The Cambourne to Cambridge Order

THE CAMBOURNE TO CAMBRIDGE ORDER

PROOF OF EVIDENCE

On behalf of Cambridgeshire County Council

Proposed Bat Crossings

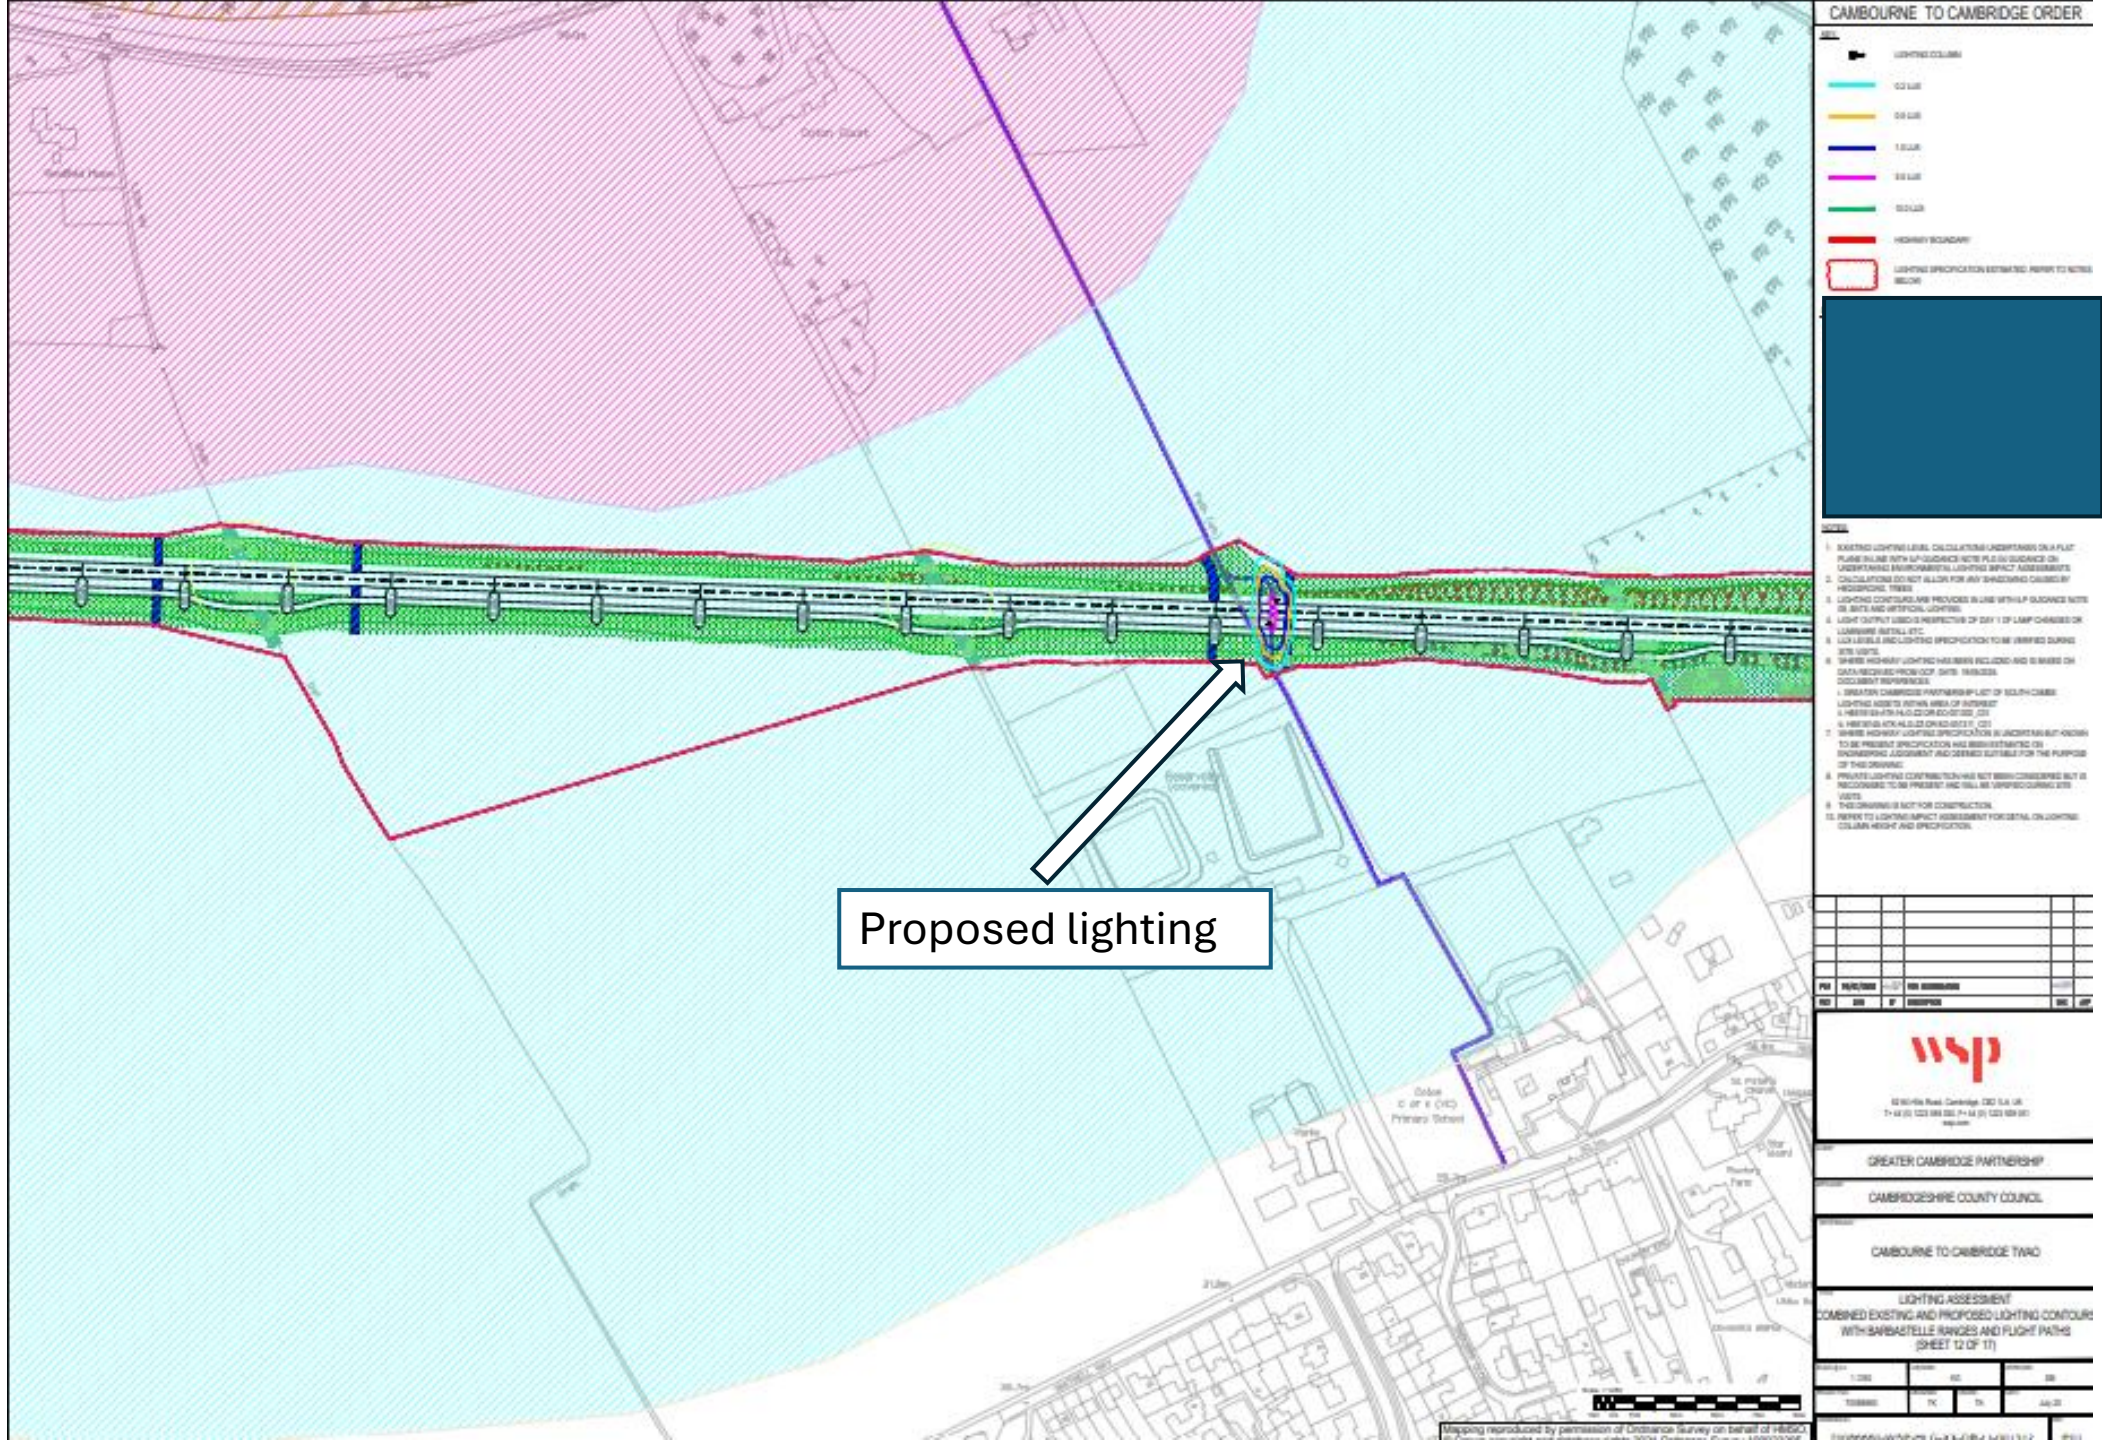
3. Crossing points should be shown to have no change from the baseline. There should not be just 'some' mitigation/buffering for increased levels of lighting, as is stated in paragraph 7.4.27 of the Technical Report 5 – Ecology [C2C-11-TR05-00] – the increased lighting should be completely mitigated for where it needs to be.

ISSUE	NATURAL ENGLAND'S POSITION	APPLICANTS POSITION	STATUS
	<p>3. Crossing points should be shown to have no change from the baseline. There should not be just ‘some’ mitigation/buffering for increased levels of lighting, as is stated in paragraph 7.4.27 of the Technical Report 5 – Ecology [C2C-11-TR05-00] – the increased lighting should be completely mitigated for where it needs to be.</p>	<p>Areas where there are landscape treatments where bat are currently unlit; will remain unlit; and will be maintained as such.</p>	<p>TO BE DISCUSSED</p>
